# Service Bulletin

Bulletin No.: PI0886

**Subject:** Electric Power Steering System Squeak Noise/Whining or Sticking when Turning Steering Wheel

**Models:** 2012-2013 Chevrolet Cruze, Volt  
Equipped with Electronic Power Steering

3225896

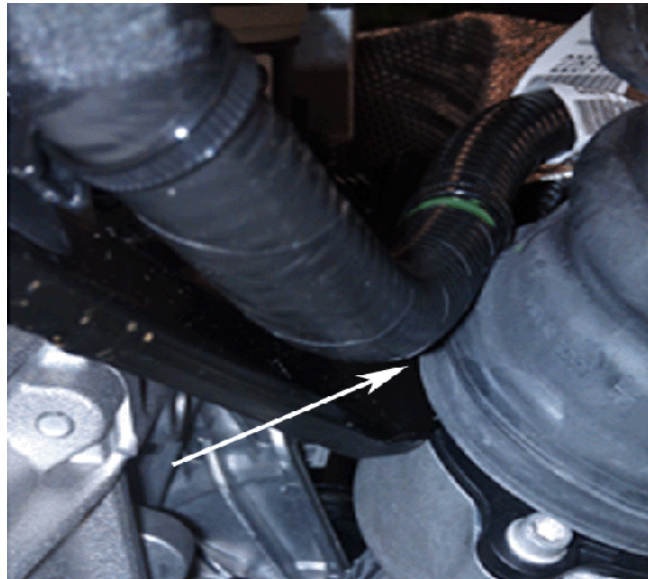
This condition may be caused by the electronic power steering (EPS) wire harness bracket contacting the steering column seal.

Technicians should inspect the EPS wire harness bracket and make sure that the bracket is not contacting the steering column seal. If contact is observed, manually adjust the EPS bracket to obtain an 8-12 mm (0.31-0.47 in) clearance from the steering column seal.
